HISTORIC AND DESIGN REVIEW COMMISSION

September 02, 2020

HDRC CASE NO: 2020-371
ADDRESS: 606 KAMPMANN BLVD
LEGAL DESCRIPTION: NCB 9078 BLK LOT 17 AND E 1.5 FT OF 16
ZONING: R-6,H
CITY COUNCIL DIST.: 7
DISTRICT: Monticello Park Historic District
APPLICANT: Alfred Gomez/GOMEZ ALFRED
OWNER: Alfred Gomez/GOMEZ ALFRED
TYPE OF WORK: Modifications to existing front walkway
APPLICATION RECEIVED: August 06, 2020
60-DAY REVIEW: Not applicable due to City Council Emergency Orders
CASE MANAGER: Stephanie Phillips

The applicant is requesting a Certificate of Appropriateness to replace the existing continuous concrete front sidewalk with concrete pavers.

PROPOSED NEW SIDEWALK

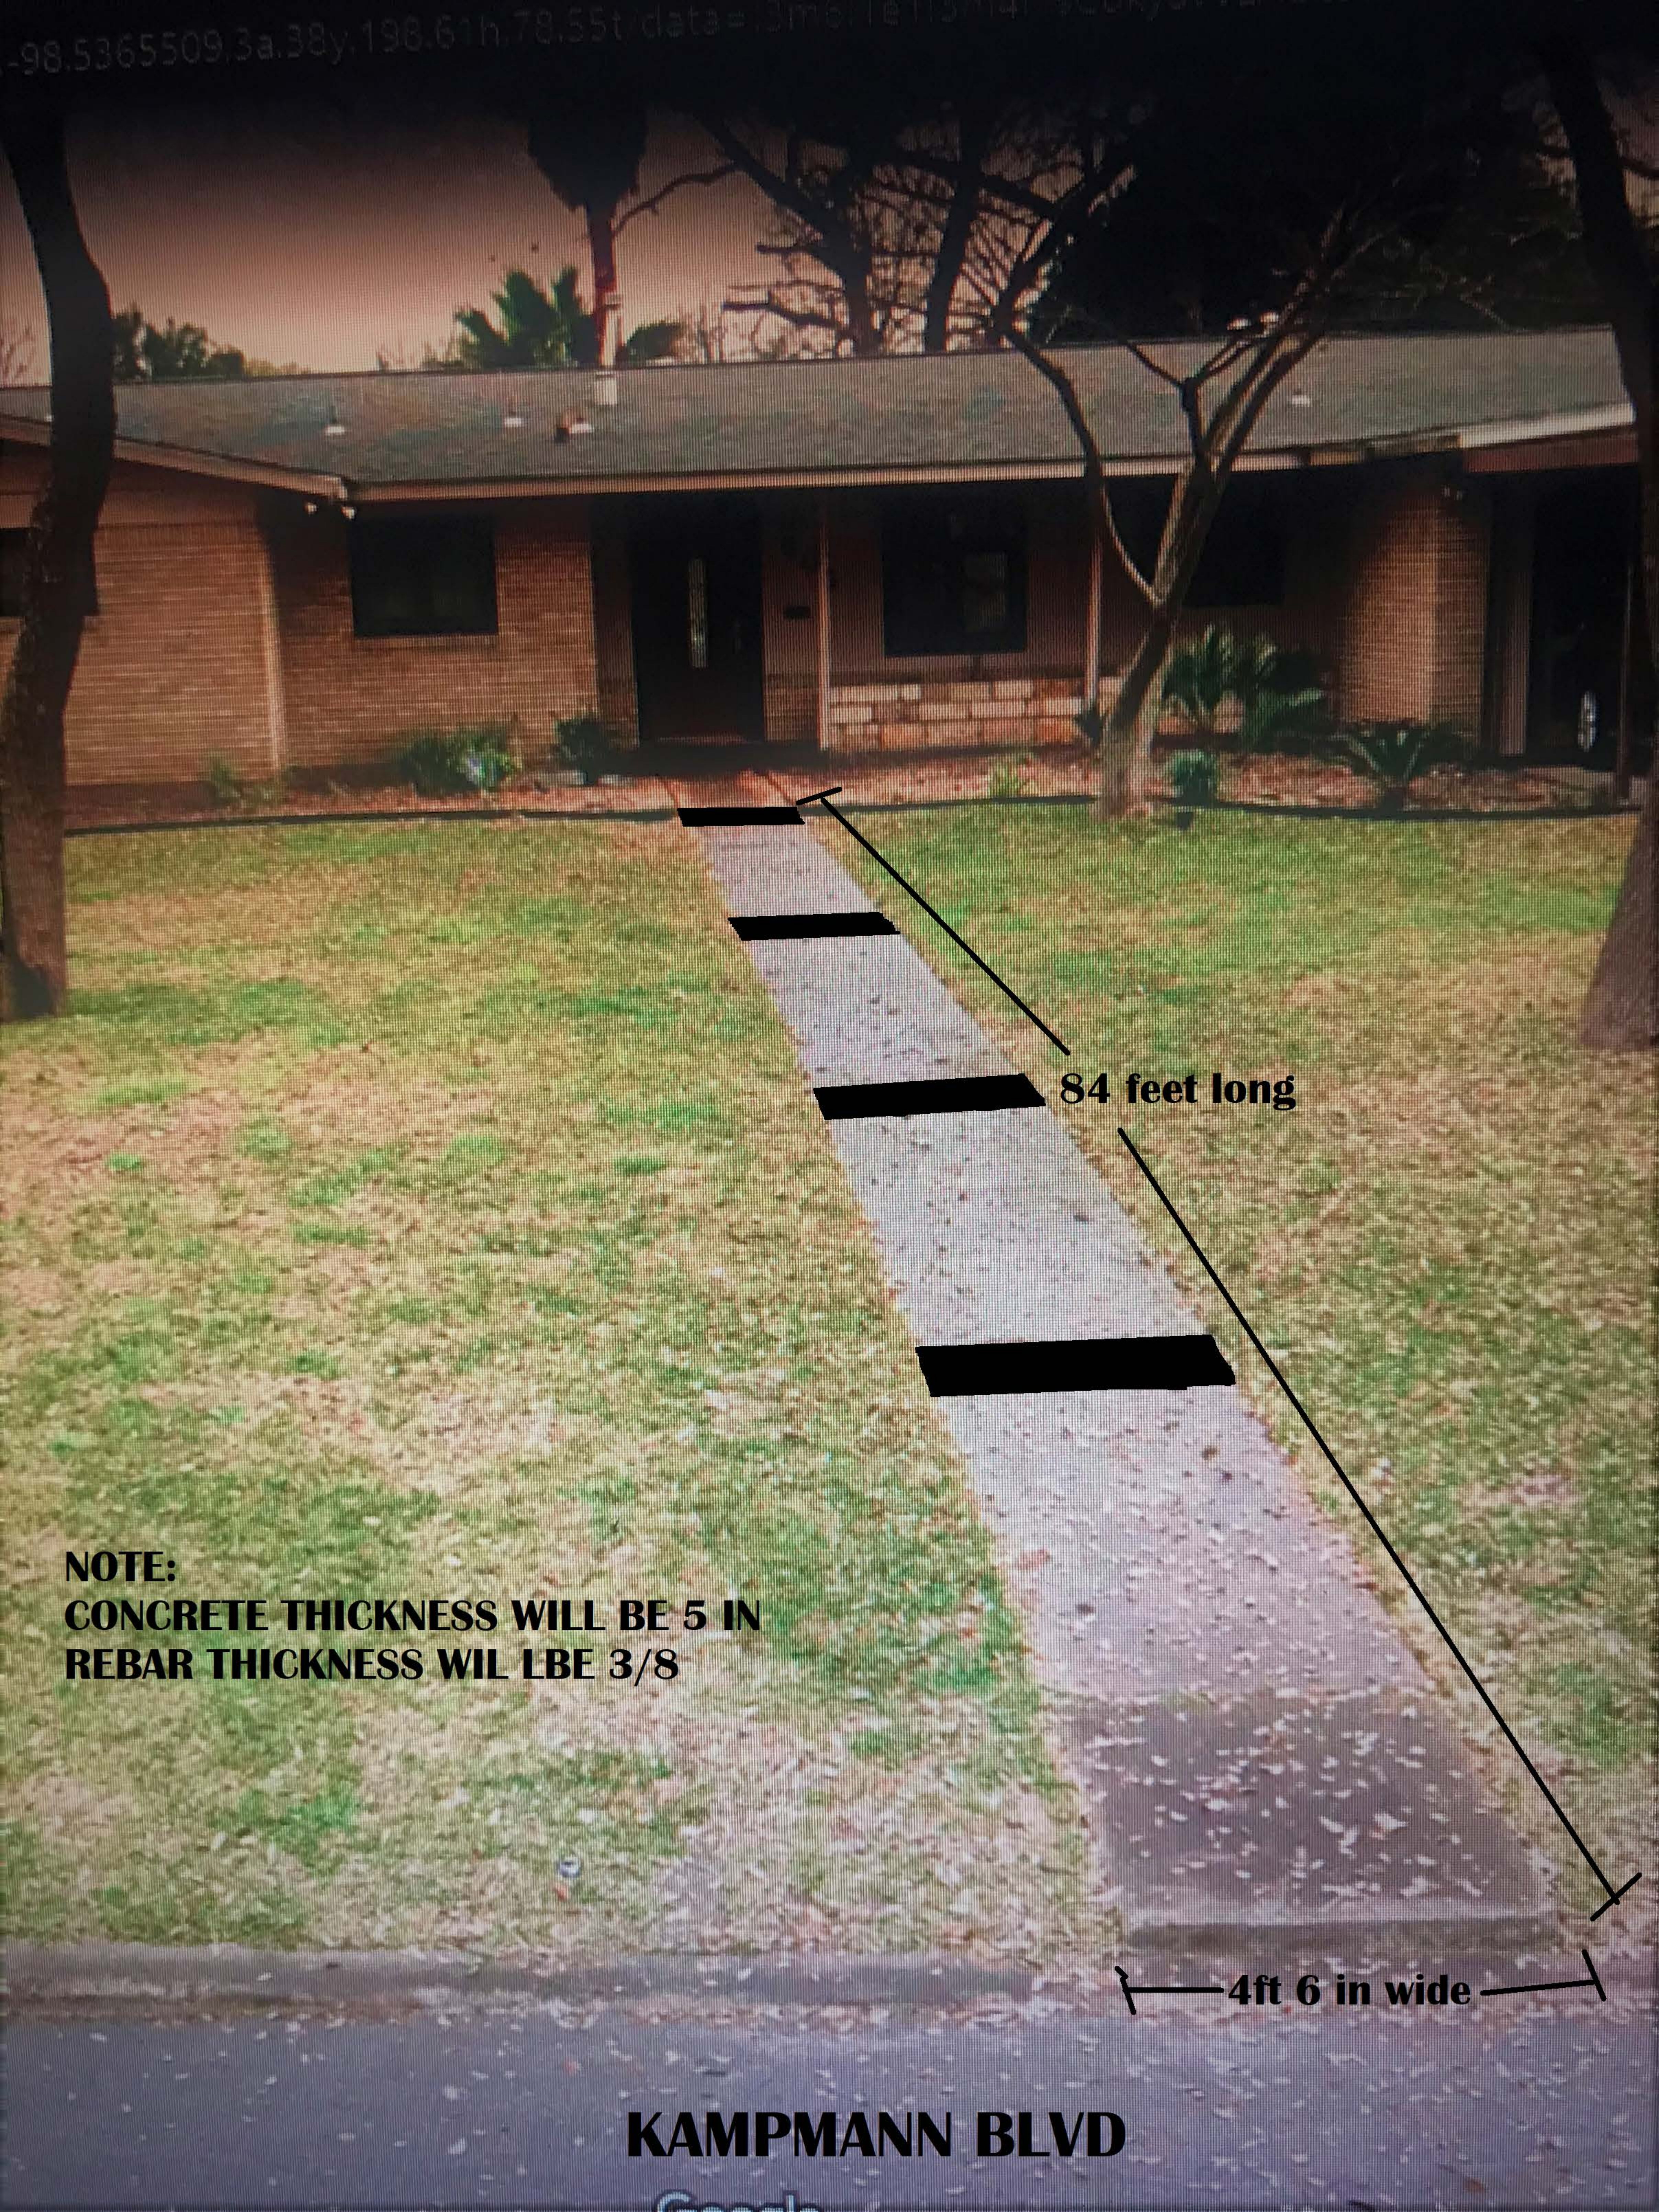
- b. WALKWAY – The applicant is proposing to remove the existing continuous concrete walkway leading from the street to the porch with a walkway constructed of individual concrete pavers. Per the applicant, the existing walkway is sinking and in need of replacement. According to the Historic Design Guidelines, walkways should be replaced in-kind and follow the historic alignment, configuration, and width of those historically found in the district. The historic width, alignment, or design should only be altered where absolutely necessary to accommodate the preservation of a significant tree. Staff does not find the proposal consistent with the Guidelines.

Staff does not recommend approval based on in finding b. The repouring of the walkway in-kind is eligible for administrative approval.
